UNITED STATES PATENT AND TRADEMARK OFFICE

10/529,558

Office Action Summary	Application No. 10/529,558	Applicant(s) MIZUNO ET AL.	
	Examiner Jeffrey Sharp	Art Unit 3677

DETAILED ACTION

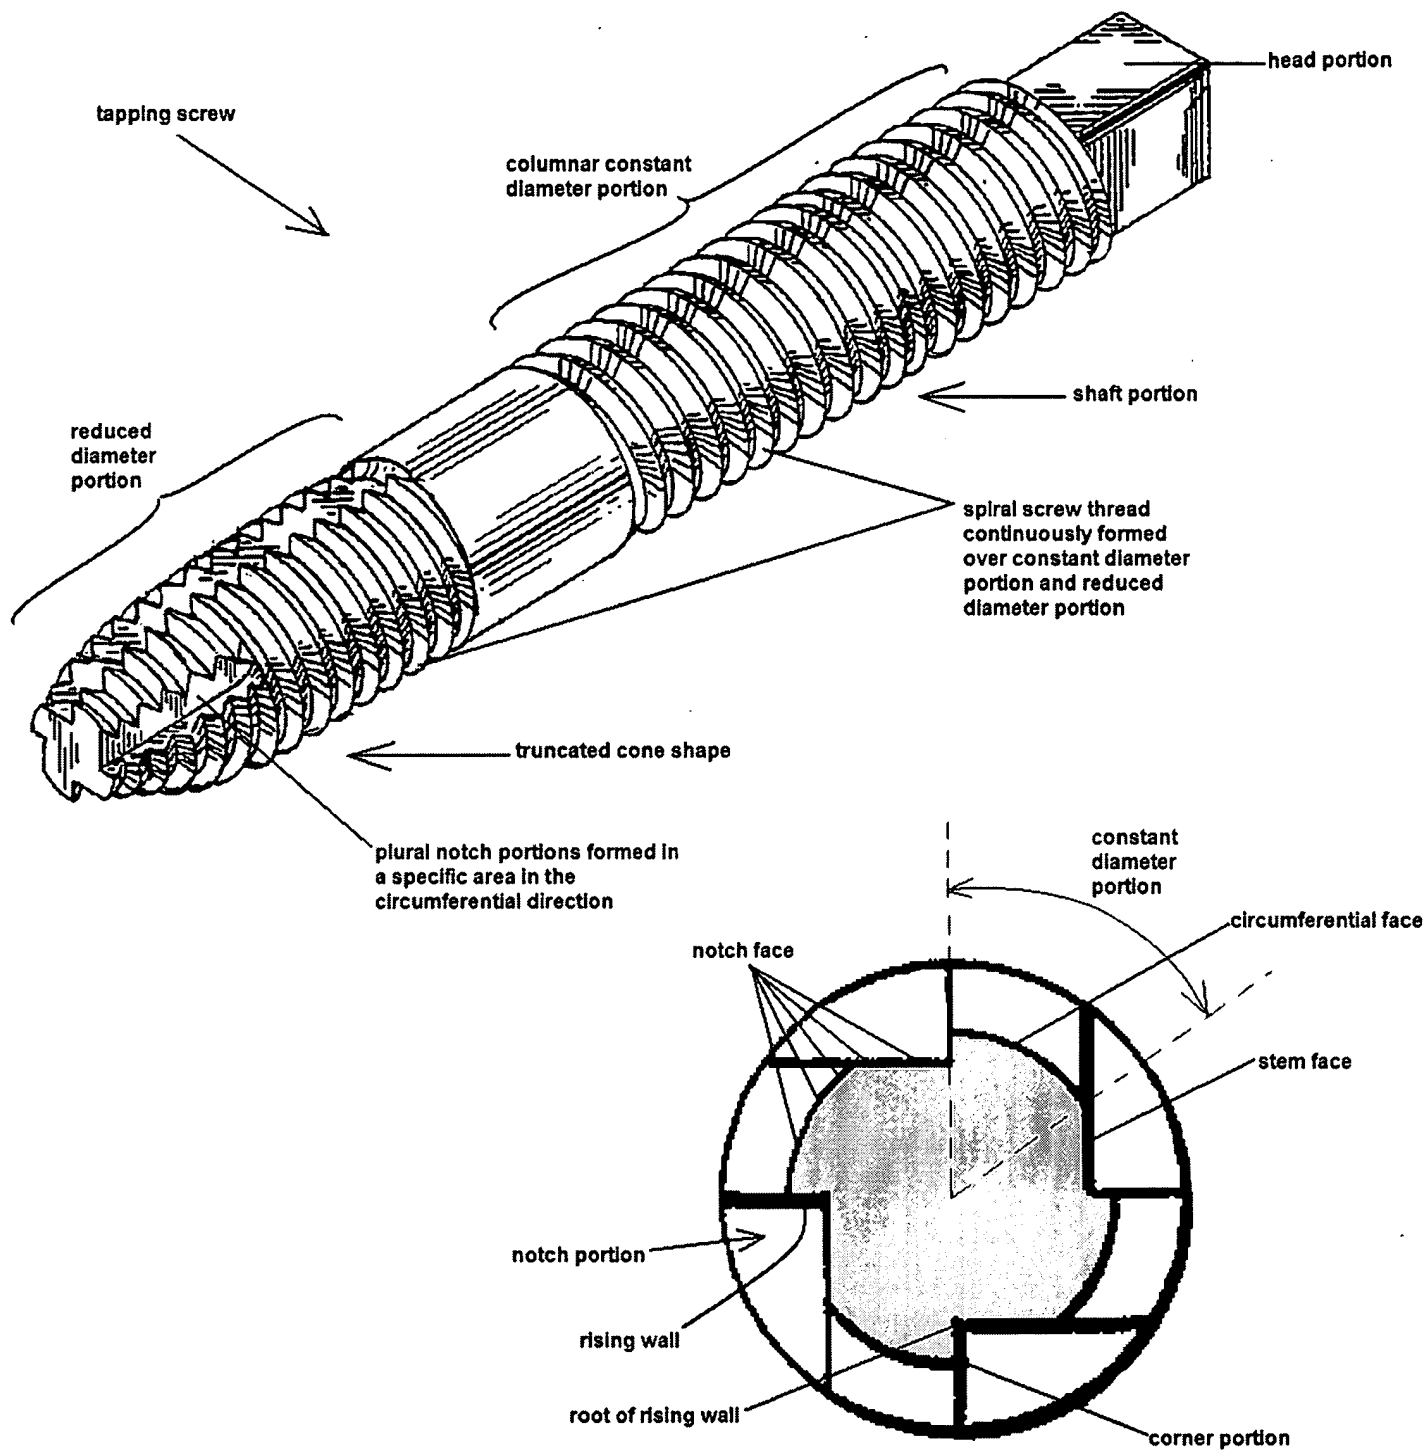
[5] Claims 1-8 (as they are understood) rejected under 35 U.S.C. 102(b) as being anticipated by Russo US-4,673,323 as clearly illustrated below.

In short, Russo teaches a tapping screw having a head portion, shaft portion having a thread, and truncated cone shape portion having a thread. The truncated cone shape portion is a reduced diameter portion having plural notch portions in a specific area. Each of said notch portions includes a notch face, rising wall, and corner portion formed at a diametrical outside of the rising wall; wherein said notch face has a stem face notched and formed on the diametrical inside from the top of said thread. The thread is (broadly) "shaved" at a top portion thereof, and at least a portion of the screw thread is left in said specific area.
